Subject: Interstate 4 from East of County Road 532 to Central Florida Parkway Value Engineering Study Recommendation Dispositions

FPID: 431456-1 & 242484-8

### Value Engineering Study Final Report

**RECOMMENDATION No. 2: The C-D road between Daryl Carter Parkway and Central Florida Parkway can be brought closer together to shorten the lanes**

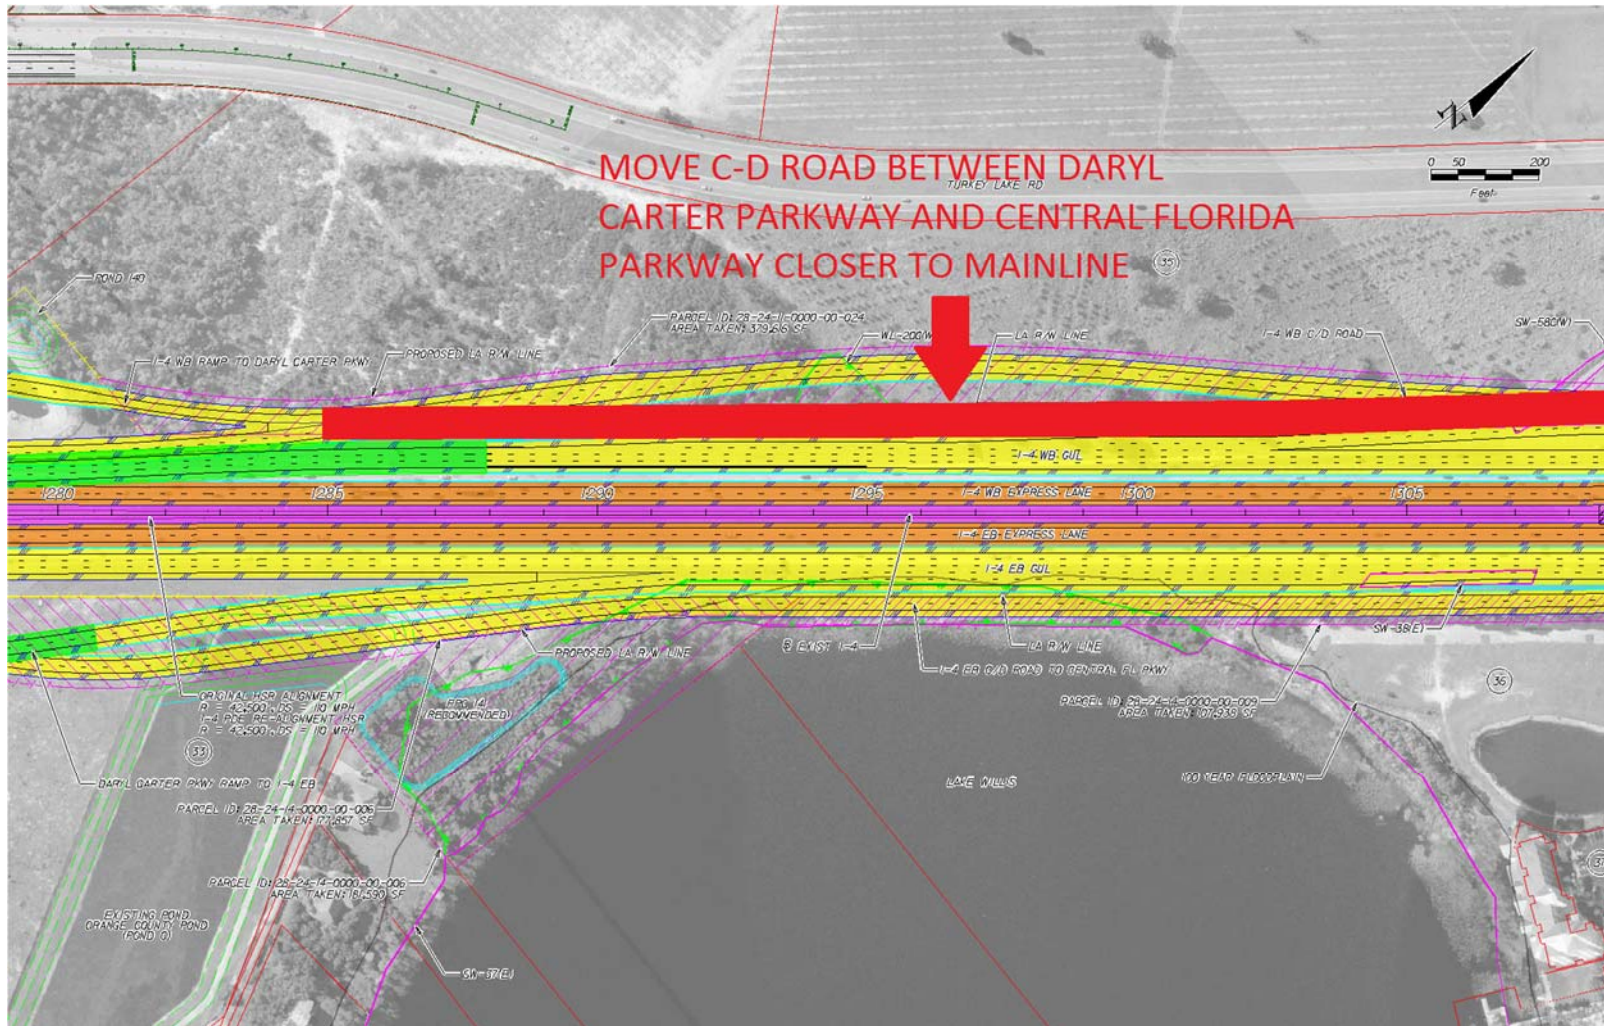
Recommendation 2: The C-D road between Daryl Carter Parkway and Central Florida Parkway can be brought closer together to shorten the lanes.

The PD&E Documents show the westbound Collector-Distributor road on the north side of the mainline jogging away from the mainline and into a curve between Daryl Carter Parkway and Central Florida Parkway.

Accepted.

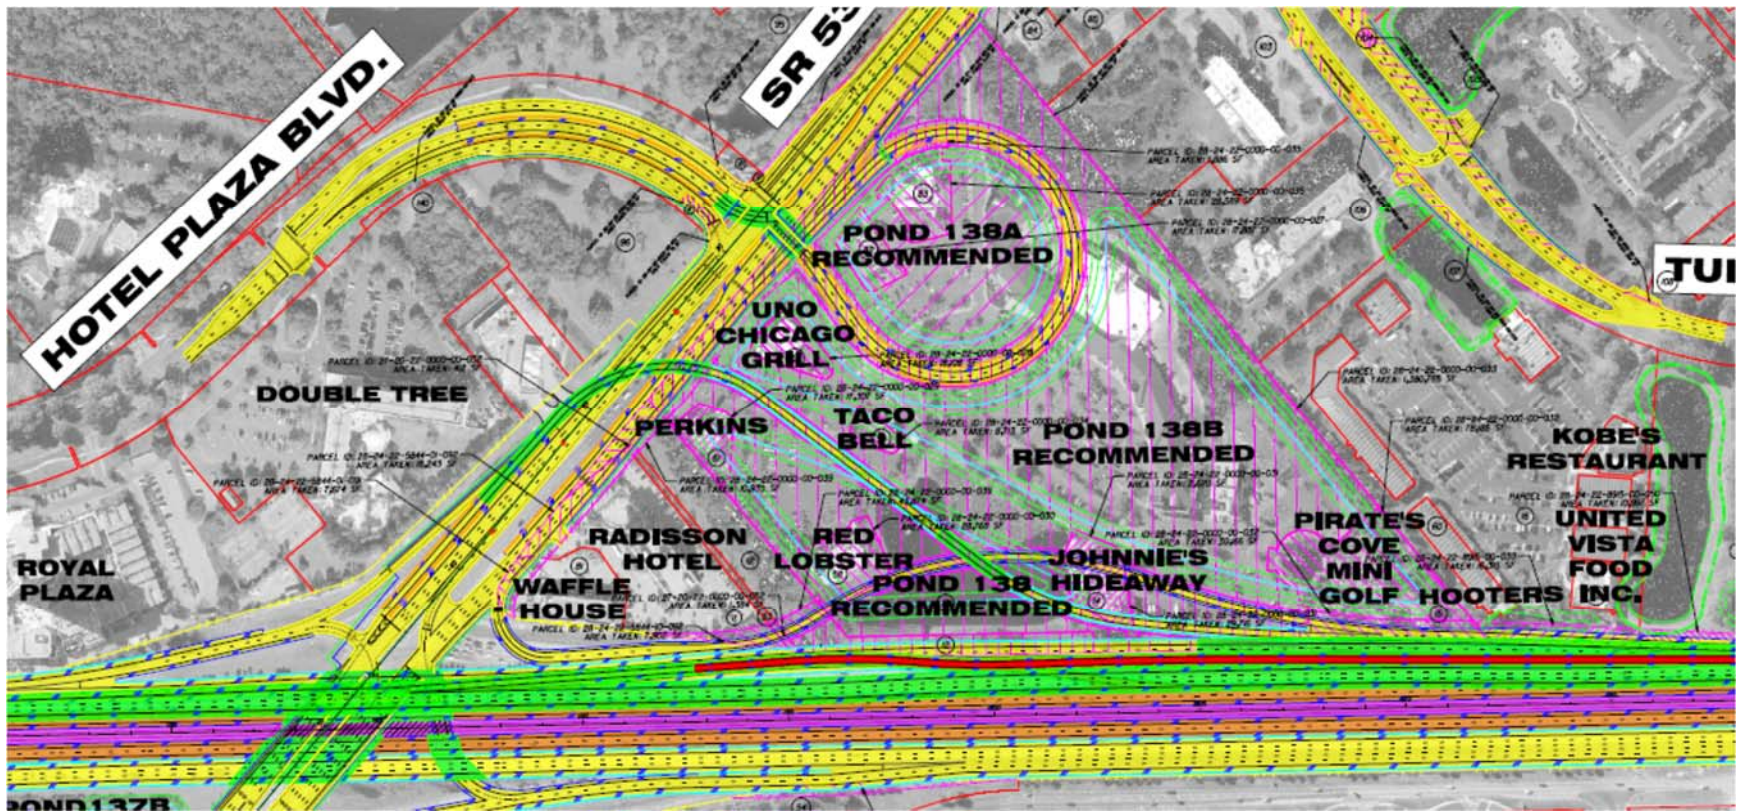
Recommendation 3: Use early right of way acquisition of Crossroads and move to design-build-finance concept of delivery.

The PD&E Documents show the Crossroads commercial area right of way acquisition in 2024 and construction letting in 2025. The proposed delivery method is Design-Build.

Accepted.

**RECOMMENDATION No. 4: Straighten the express to toll eastbound to northbound ramp at SR 429 to shorten the ramp and expand 106A pond**

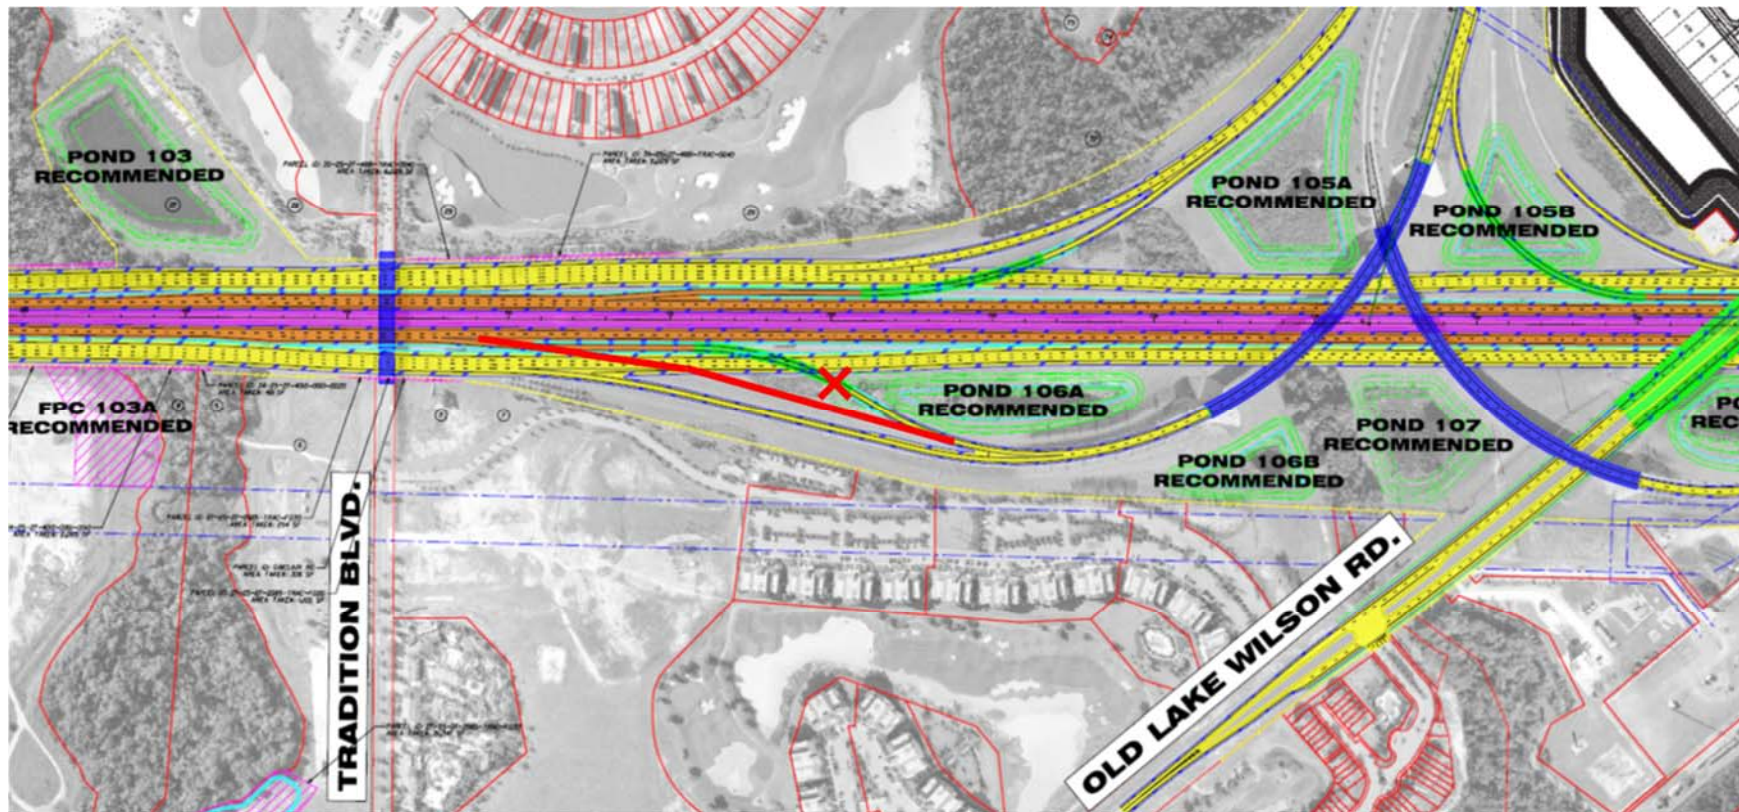
Recommendation 4: Straighten the express to toll eastbound to northbound ramp at SR 429 to shorten the ramp and expand 106A pond.

The PD&E Documents show the eastbound express lane going over the general use eastbound lanes (around Station 716+00 to Station 720+50) and circumventing around the outside (south side around 720+50 to 730+00) of the Pond 106A to connect to the northbound SR 429 toll road.

Pending further analysis. The design team will analyze this recommendation during the line and grade phase of the project.

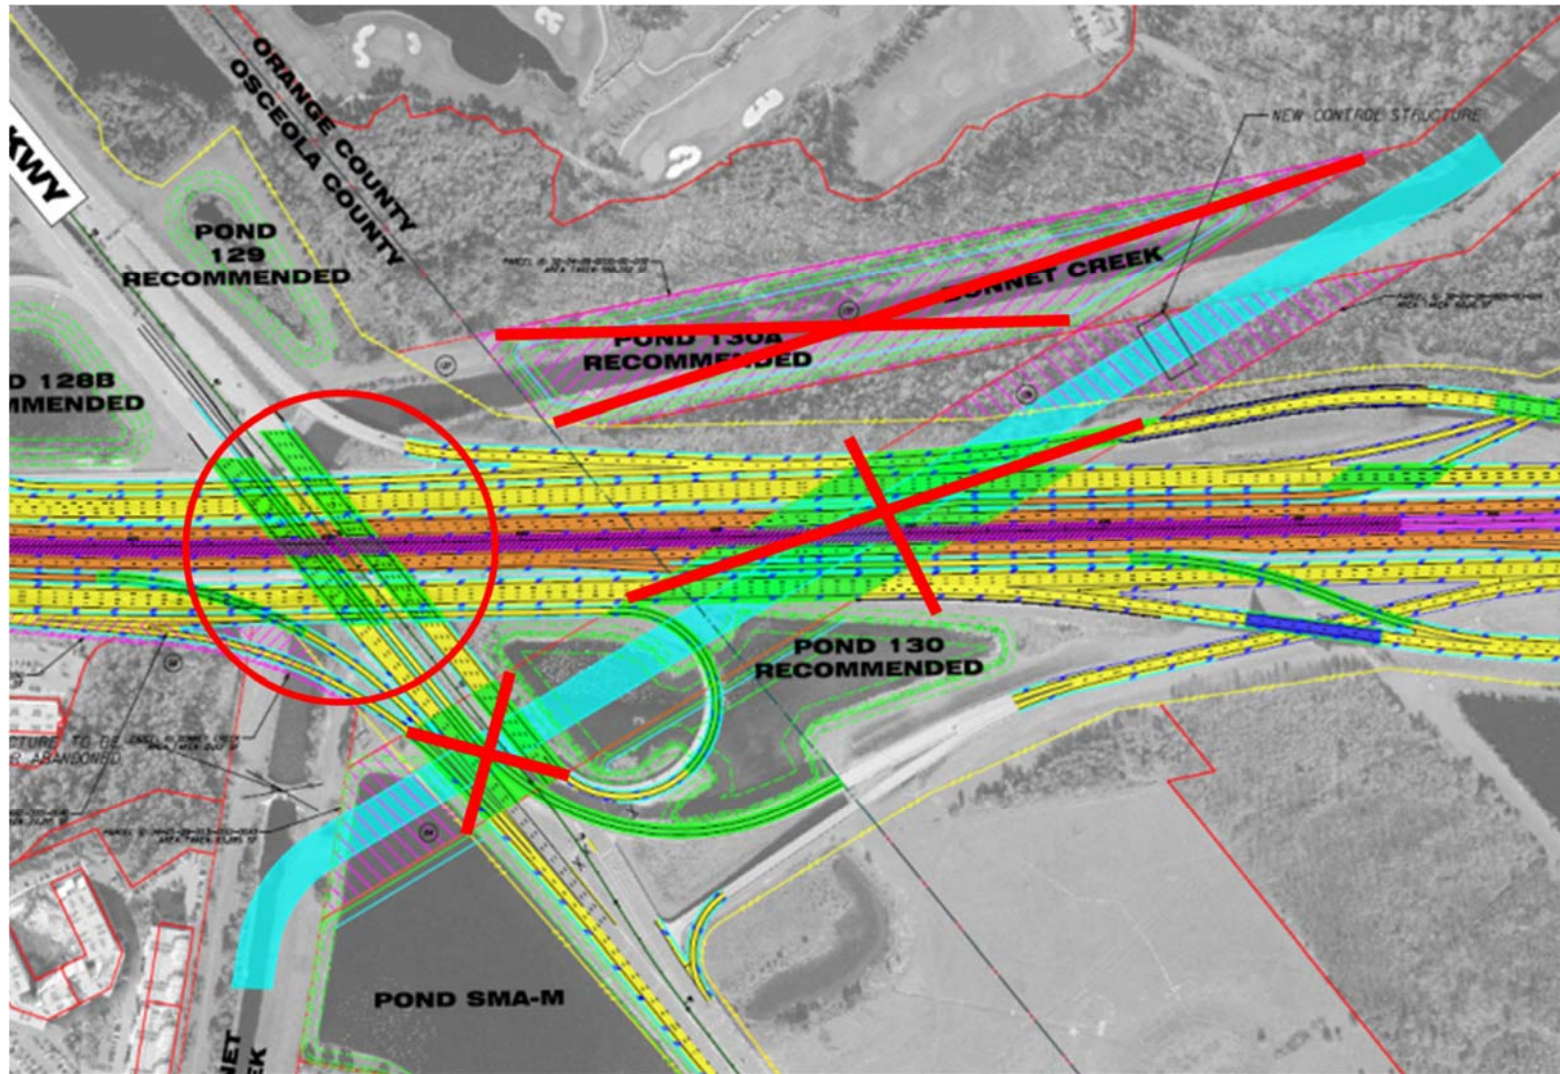
Recommendation 5 & 6: Do not realign Bonnet Creek at Osceola Parkway; reconstruct bridges in the current locations.

The PD&E Documents show realignment of Bonnet Creek with new larger skewed I-4 bridges crossing the Bonnet Creek realignment and additional bridges on Osceola Parkway also to span realigned Bonnet Creek.

Replace I-4 bridges in current location without Bonnet Creek realignment.

Accepted. Structures maintenance is OK with this recommendation as long as 30-ft of vertical clearance can be achieved between I-4 and the low member of Osceola Parkway. A profile was developed and the vertical clearance can be achieved without any impacts to the entrance to Gaylord Palms.

**RECOMMENDATION No. 6: Raise the Parkway bridges profile to allow construction of the I-4 bridges with Bonnet Creek at its current location and lower the high speed rail to grade**

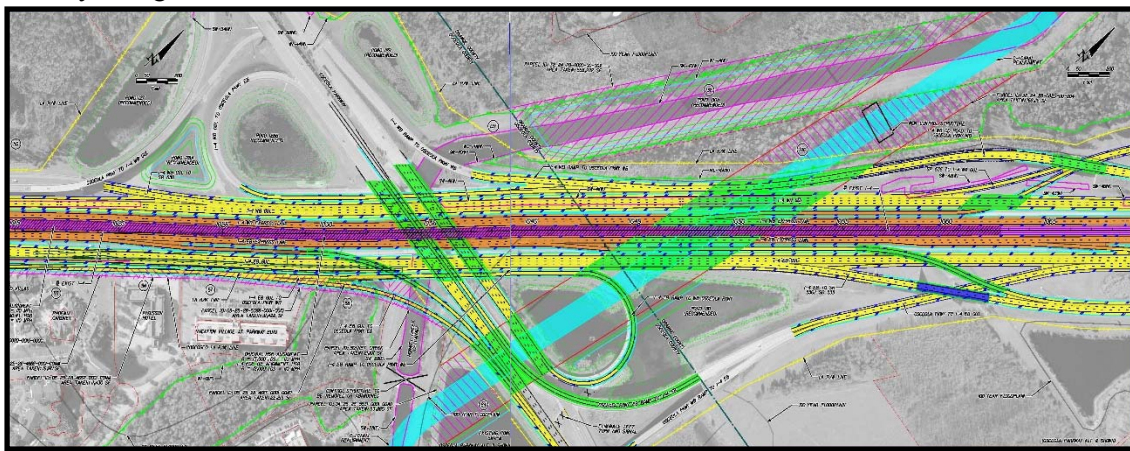
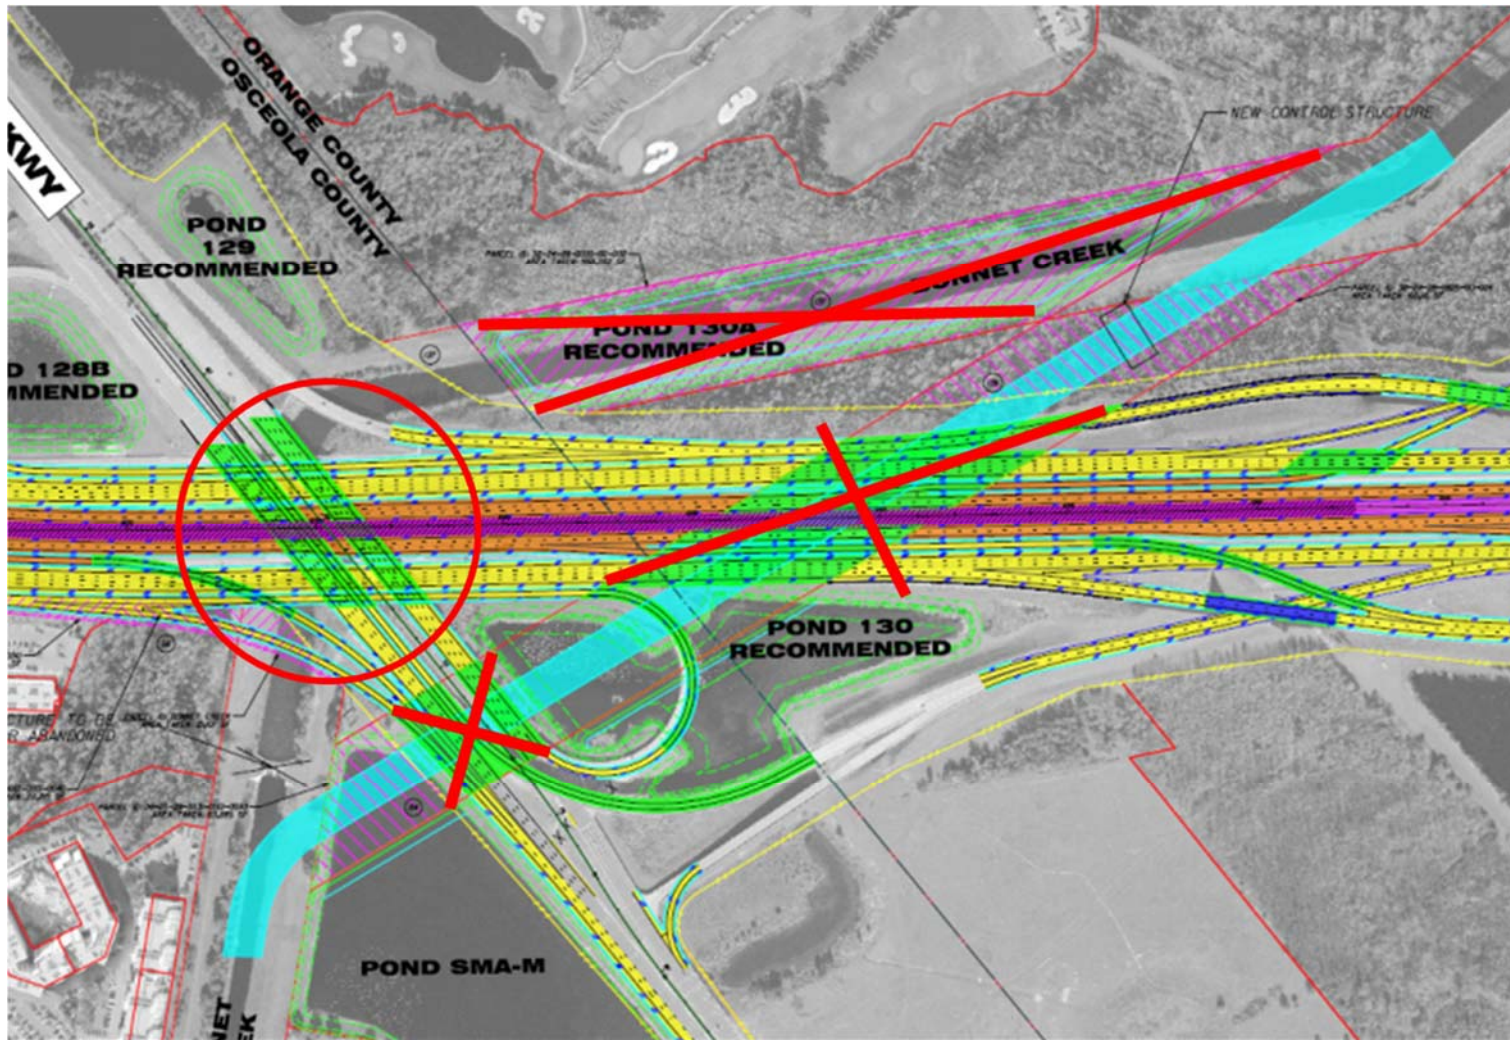
The PD&E Documents show the re-alignment of Bonnet Creek east of the interchange of I-4 and the Osceola Parkway. Bonnet Creek is skewed across I-4 and the ramps for Osceola Parkway where it reconnects to the existing Bonnet Creek. The location of the re-alignment of Bonnet Creek was coordinated with the Reedy Creek Improvement District (RCID) and only the concept shown below was approved. The bridges on I-4 are proposed to span right of way to right of way (300 feet). A control structure within the Creek will be relocated to the north side of I-4. The PD&E requires the construction of new skewed bridges over I-4, the loop ramp of Osceola Parkway and two new bridges on Osceola Parkway east of I-4. Due to the widening of I-4, the Osceola bridges will need to be reconstructed and lengthened. The proposed current clearance between I-4 and the Osceola Parkway Bridges is 23'-5".

This alternative differs from Alternative No. 5 by also raising the profile of the bridges over the Osceola Parkway to add more vertical clearance for construction and maintenance of the I-4 bridges over Bonnet Creek. This will also allow the future high speed rail to be constructed at grade instead of over the Osceola Parkway. This alternative will also require reconstruction and lengthening of the two Osceola Parkway Bridges and some changes along Osceola Parkway to tie down due to the increased profile.

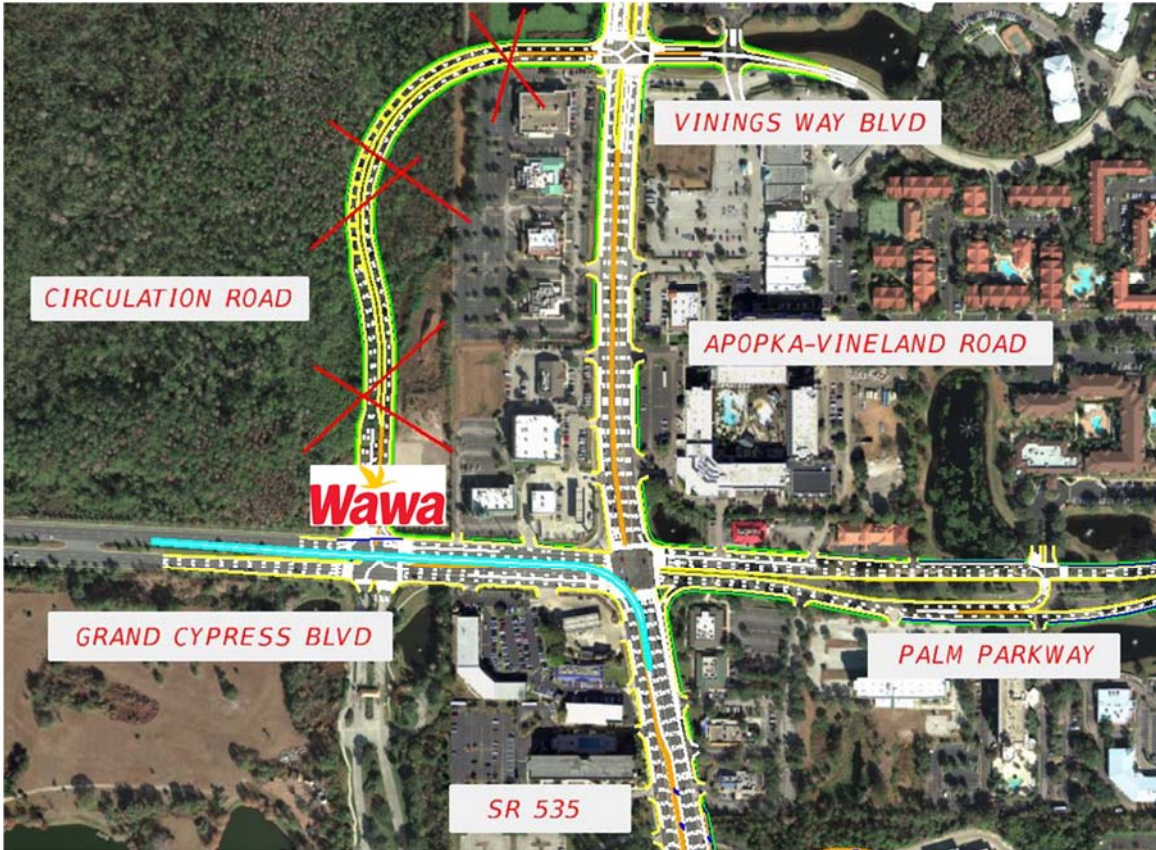
Recommendation 7: Continue two lanes of SR 535 on structure for left turn flyover to SR 535 northbound on SR 535 past the Grand Cypress intersection.

The PD&E Documents show that all left turn movements at the SR 535 and Palm Parkway intersection will be prohibited. In order to make left turns, a new roadway was constructed at the Vinings Way Boulevard intersection connecting CR 435 with SR 535.

Construct a flyover for the SR 535 northbound to westbound left turn movement. Include left turn lanes at the SR 535/Palm Parkway intersection.

Not accepted. From an operational perspective, simply removing that one movement from the at-grade intersection isn't nearly enough to make the signal work.

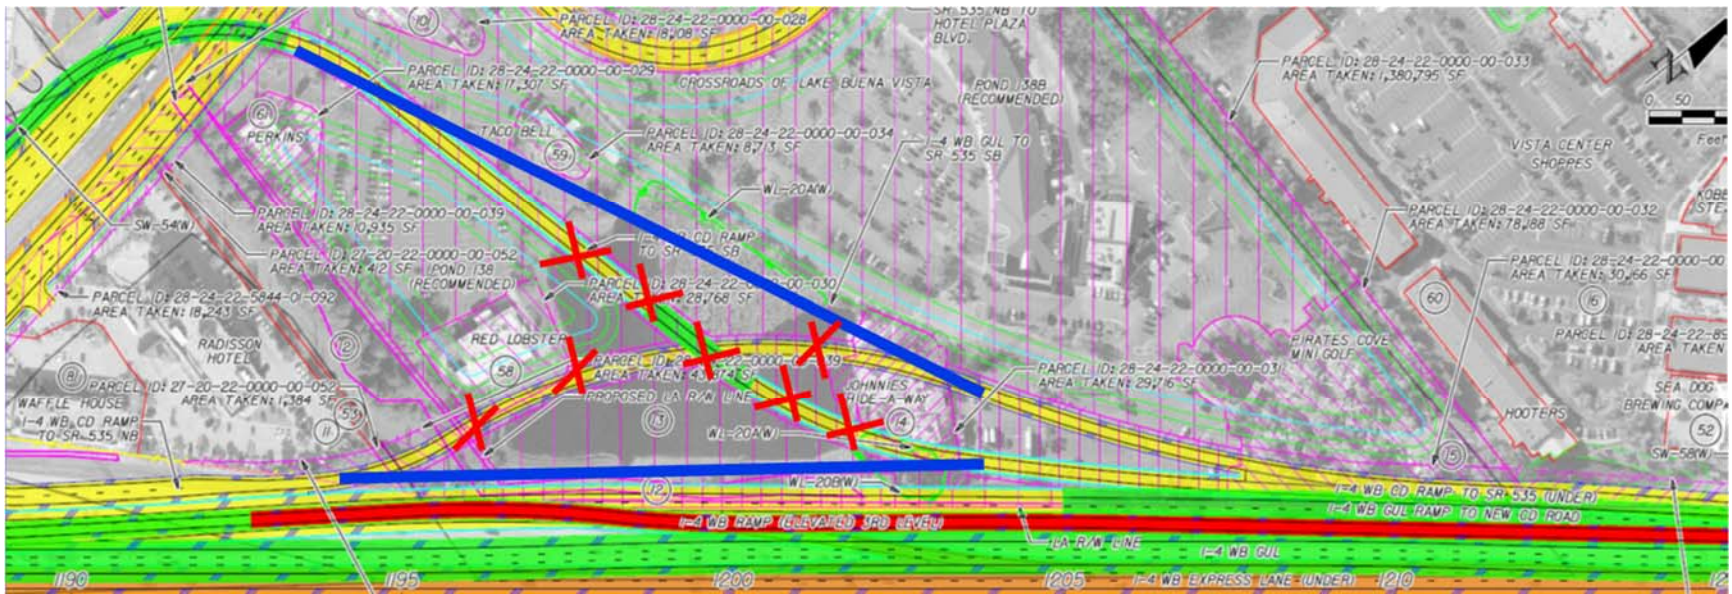
Recommendation 8: Flip the westbound I-4 exit ramps to SR 535 to shorten the lanes.

The PD&E Documents show I-4 westbound General Use Lane-Ramp to the new Collector-Distributor Road to access SR 535 northbound and southbound. The exit ramp to SR 535 has the northbound traffic under a bridge braid that carries traffic southbound.

Accepted.
